TOWN OF NEWBURGH
PLANNING BOARD
REVIEW COMMENTS

PROJECT: POND VIEW 2 LOT SUBDIVISION
PROJECT NO.: 14-19
PROJECT LOCATION: SECTION 10, BLOCK 1, LOT 50
PROJECT REPRESENTATIVE: HUDSON LAND DESIGN
REVIEW DATE: 18 AUGUST 2014
MEETING DATE: 21 AUGUST 2014

DEEP TEST HOLE TABLE:
 DEEP TEST HOLE RESULTS ESTABLISHED ON 5/2/14

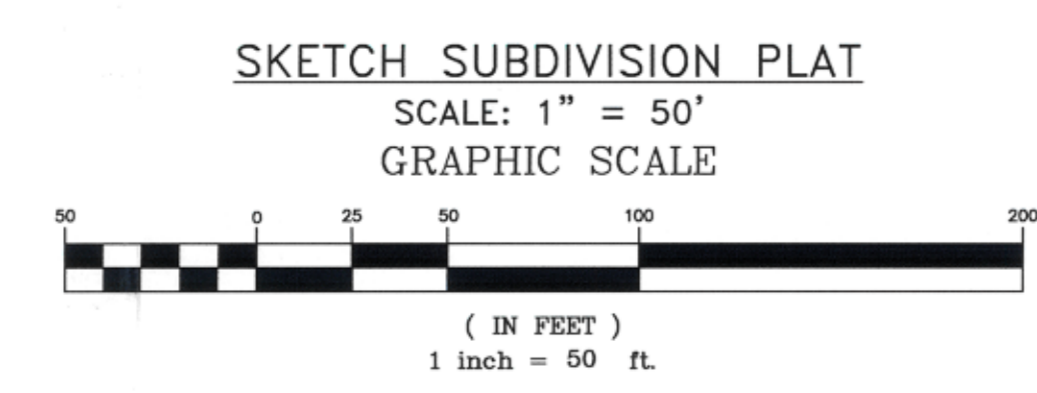
7. Revised note identifying that 30% of the culvert will be buried or four inches of the culvert.
8. Survey locations of deep and percolation tests are required. A note on the plans identifies that test locations are shown as approximate.

DRIVEWAY SECTION DETAIL
NOT TO SCALE

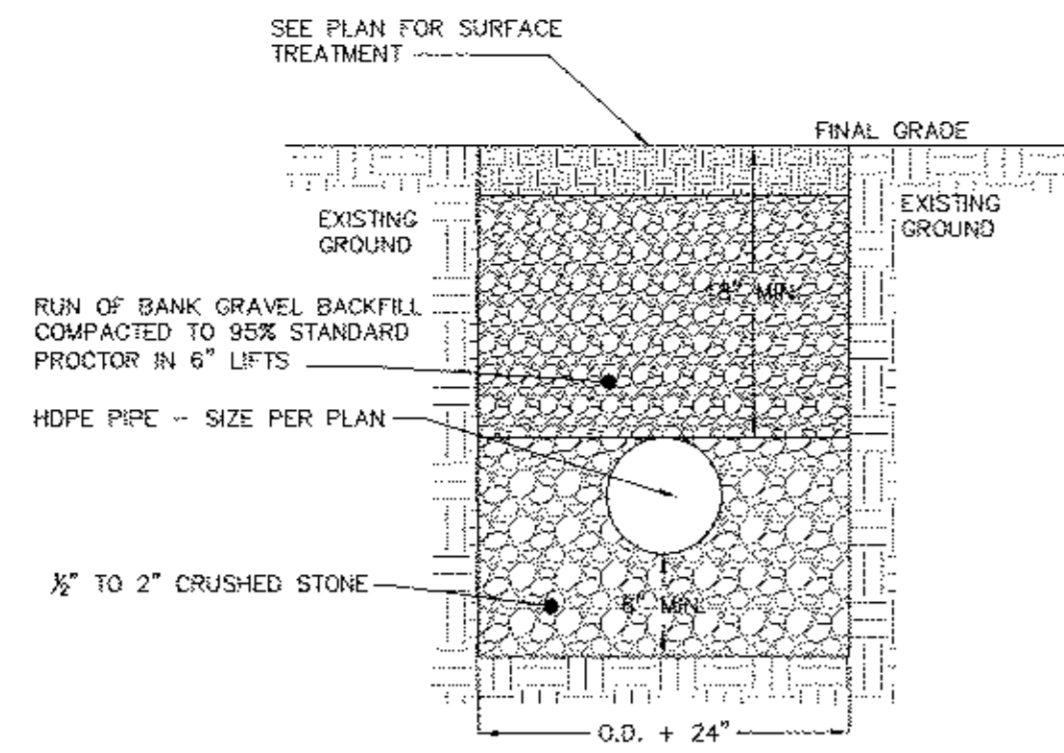
3. A driveway section detail is identified requiring geotextile fabric within the driveway section, as well as a four inch pavement section. It is unclear if this is for a certain portion of the driveway or if all driveways will receive this treatment.

LOT 1 DRIVEWAY PROFILE
SCALE: 1"=5'V
1"=50'H

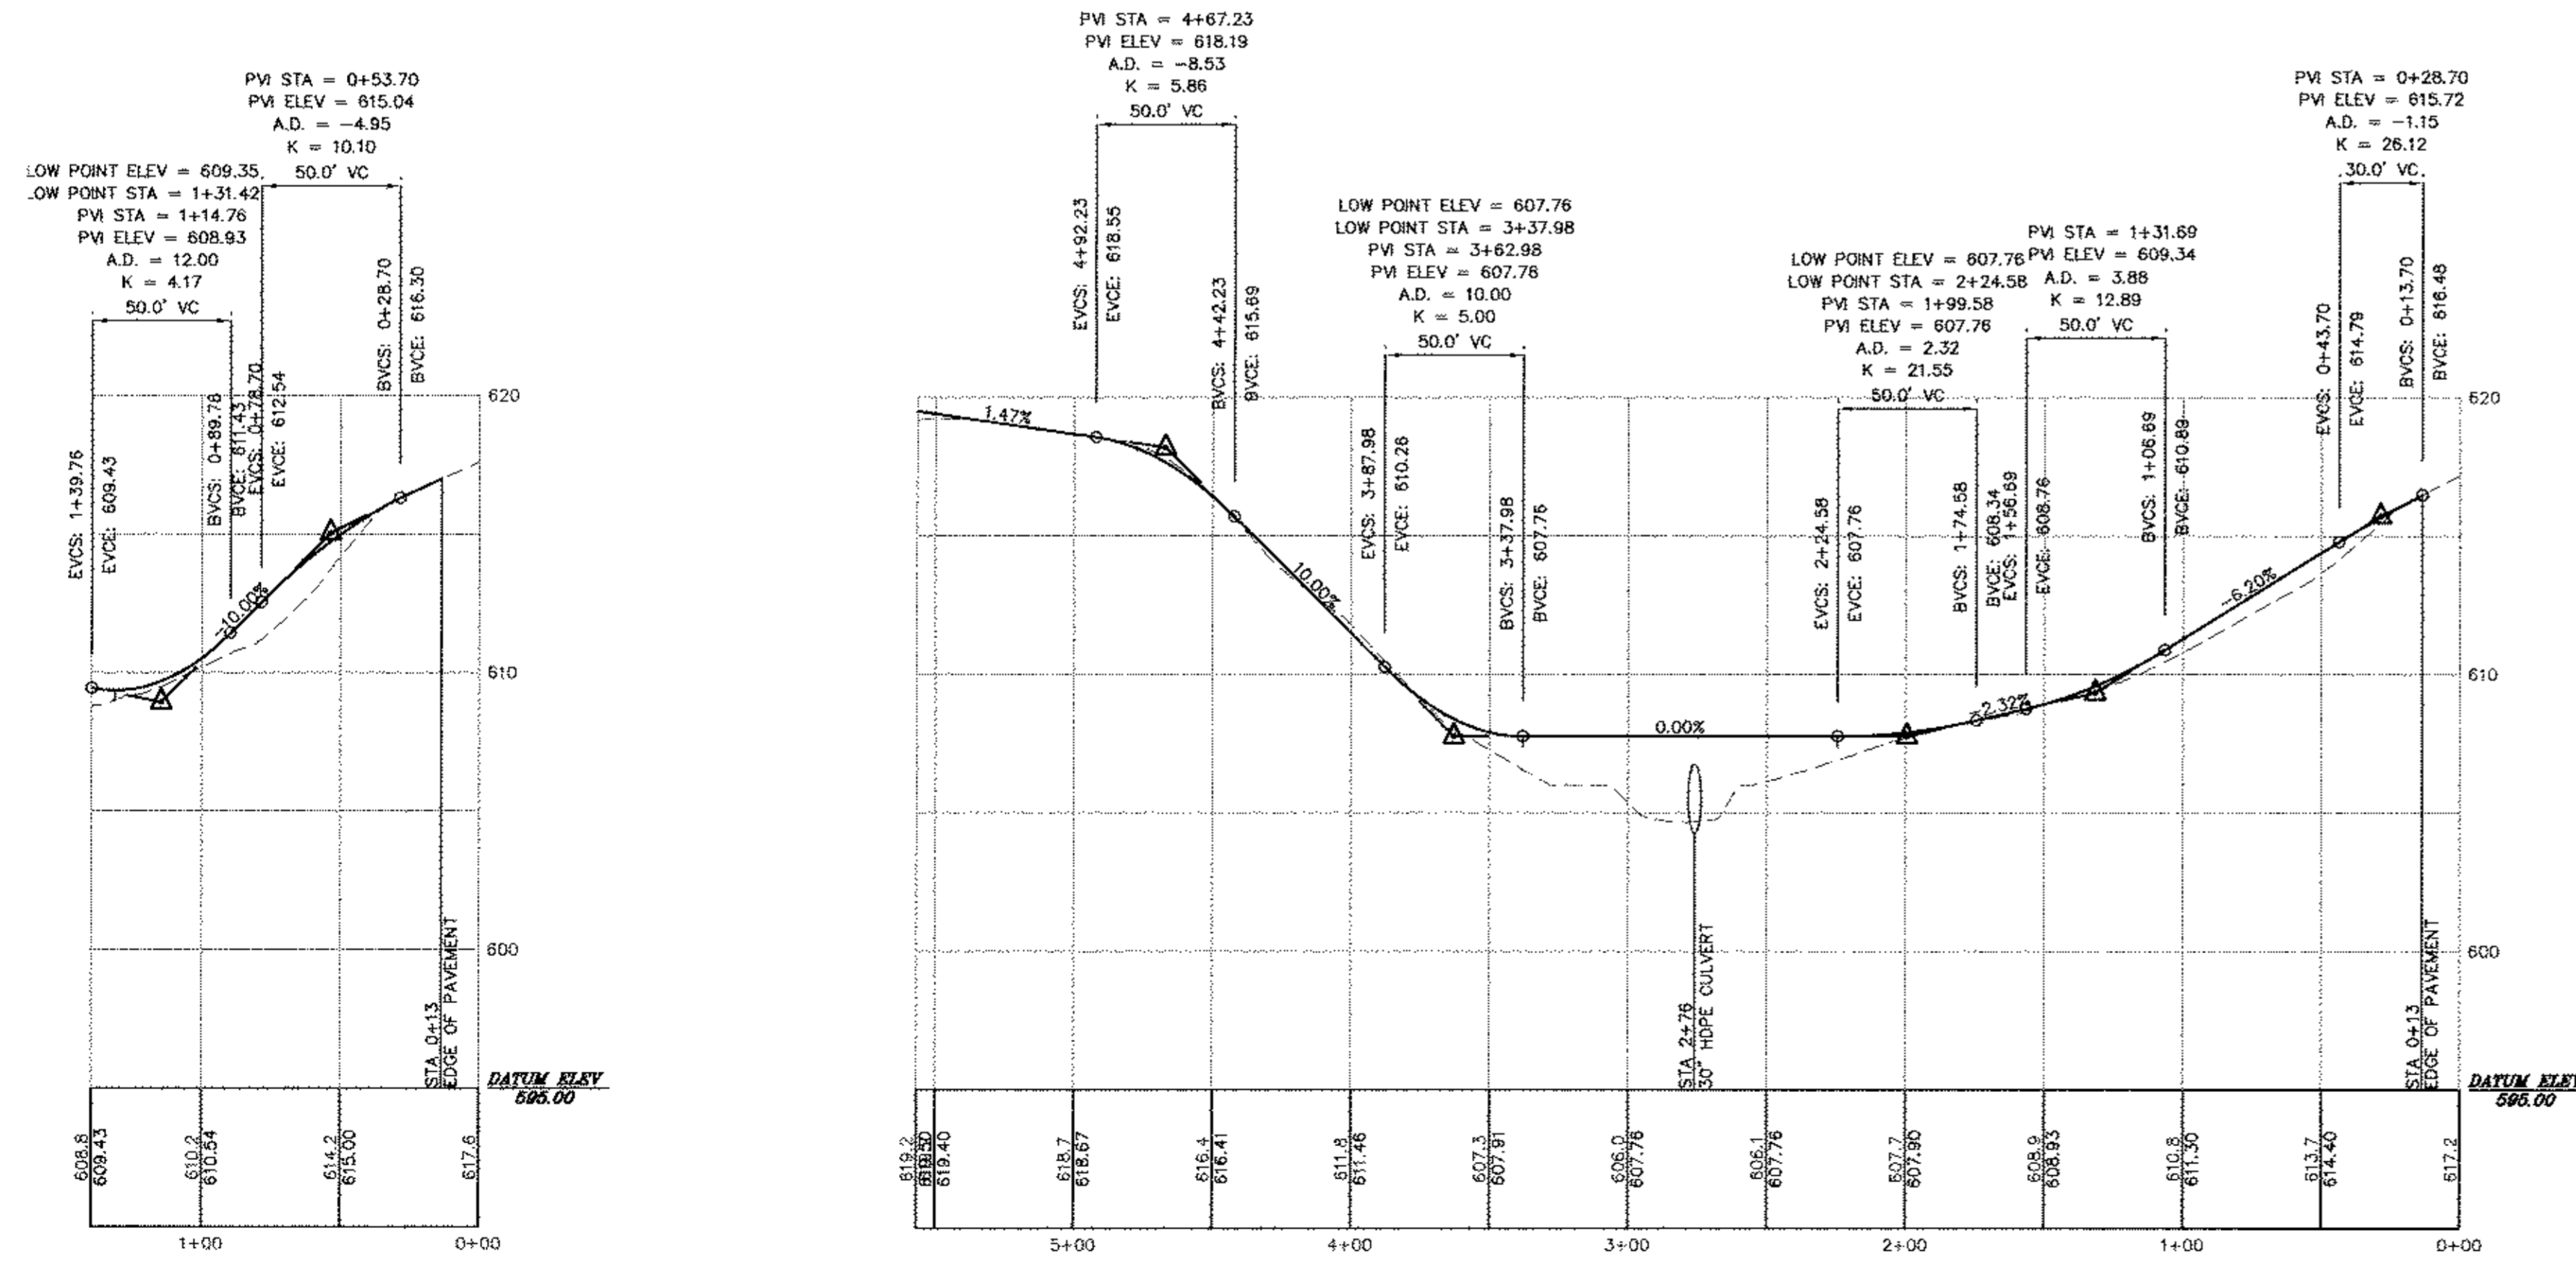
1. Map references provided identify that two foot topo information was taken from an Orange County database. This information is utilized to provide driveway cross sections at the culvert crossing. Detailed survey information in the area of the culvert crossing is required in order to identify required grading as well as wetland impacts. It appears that grading will be required across the proposed property lines and may impact adjacent stone wall along common property line to the north. Sizing information for this proposed culvert should also be provided. Culvert should be at least as large as next up gradient culvert to prevent potential ponding of the water shed above proposed driveway crossing.

1,000 GAL. SEPTIC TANK/PUMP CHAMBER DETAIL
NOT TO SCALE

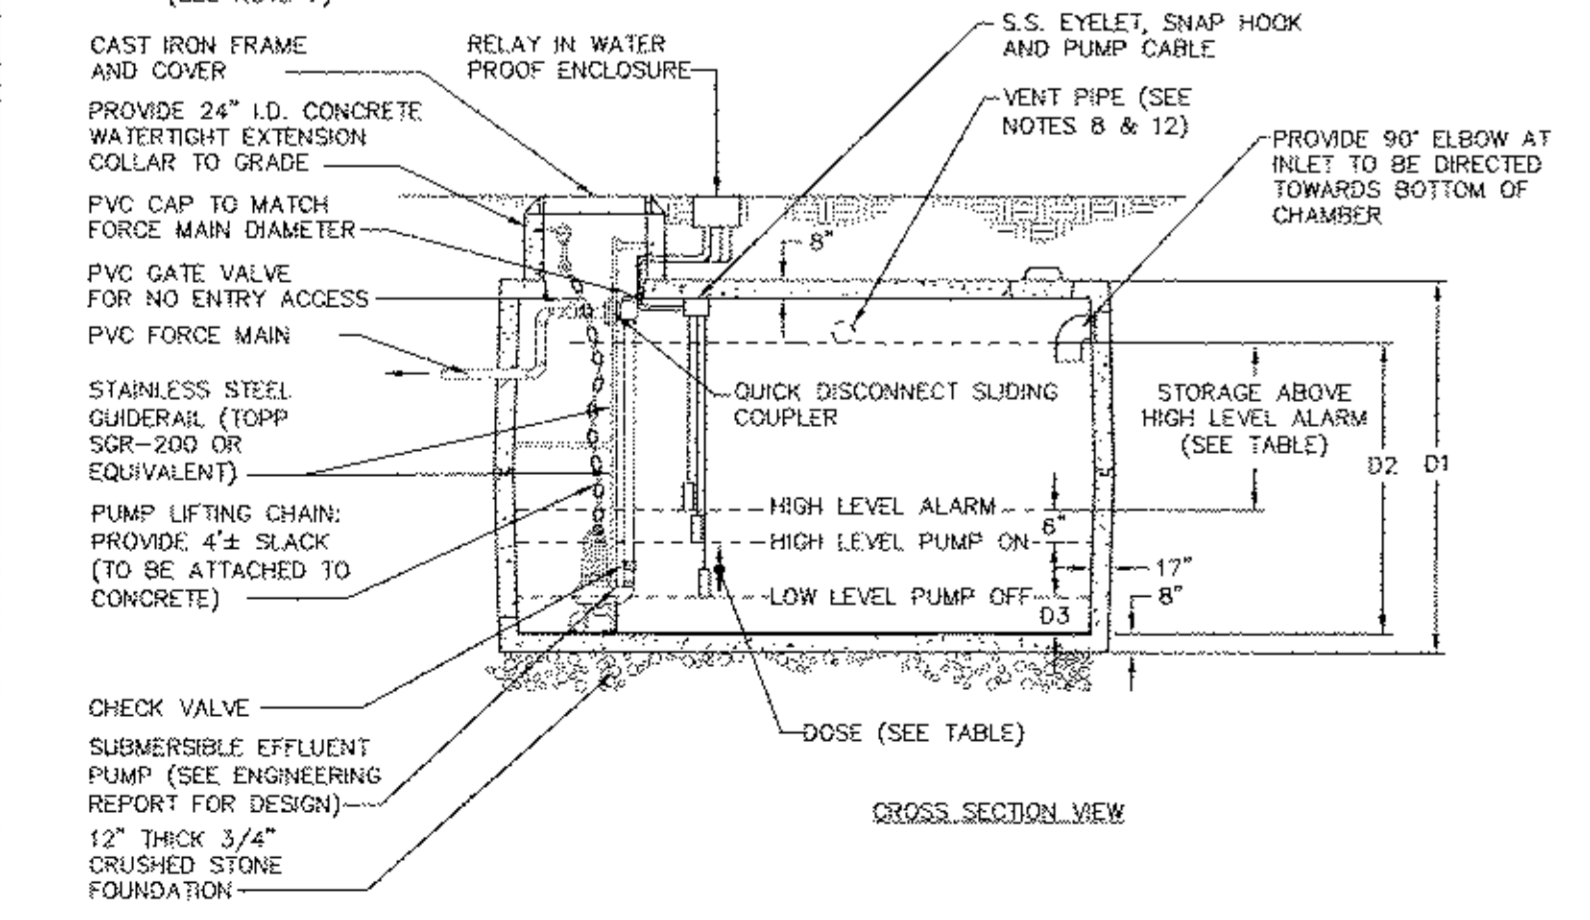
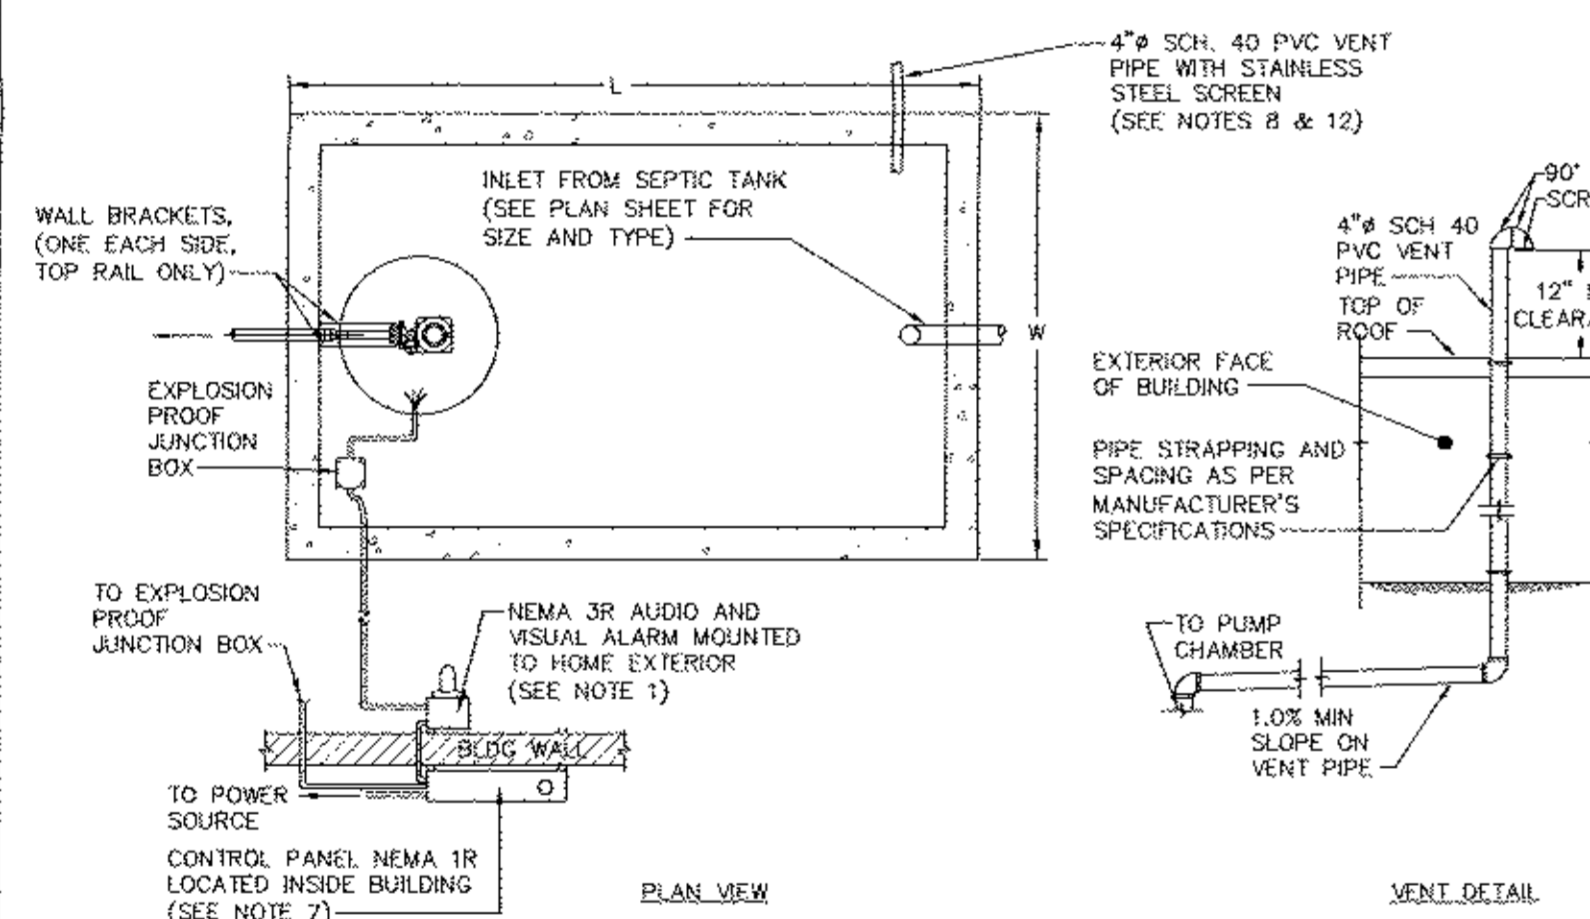
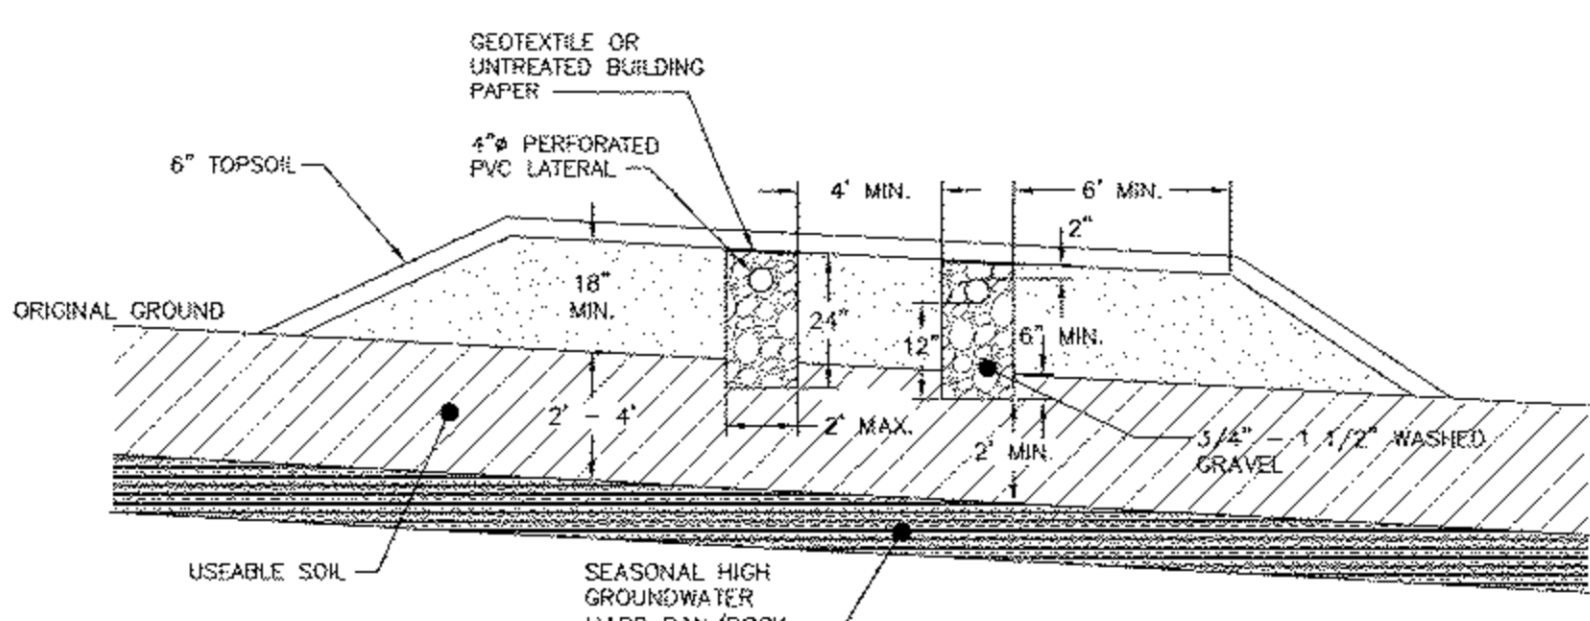
4. Dose volume for pump system must be specified for Lot 1.
5. A note identifies that a generator is required to be provided for Lot 1 as storage capacity within pump chamber is not identified.
